# Access Compliance Report

## Public Rights-of-Way

### (Curb Ramps)

Intersection ID: 20954	Main Street: SHARON_VIEW_RD	Cross Street: SOUTH_HILL_VIEW_DR	Location: SW
ADA ID: 1A213442FFC8	Ramp Type: Para	Initial Pass/Fail: Fail	Overall Compliance: No
Codes/Mitigation Info/Possible Solution		Field Measurements/Component Compliance	
Severity Score: 13.75

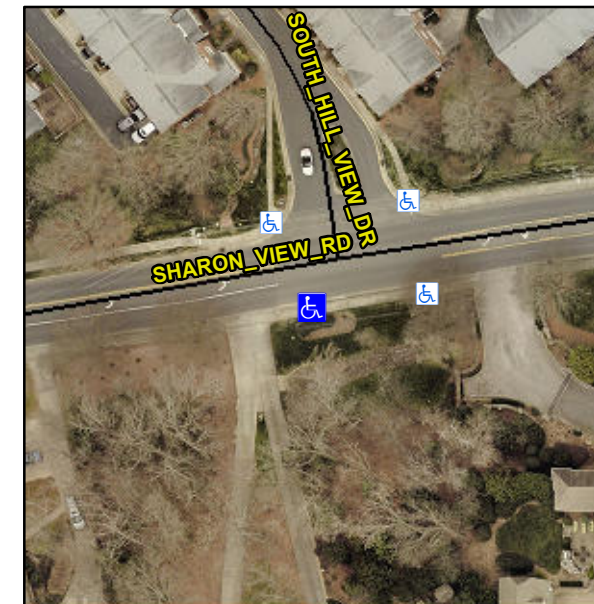
**LT RP < 5%**

**R304.5.3, R304.3.2**

**Remove & Replace Entire Ramp.**
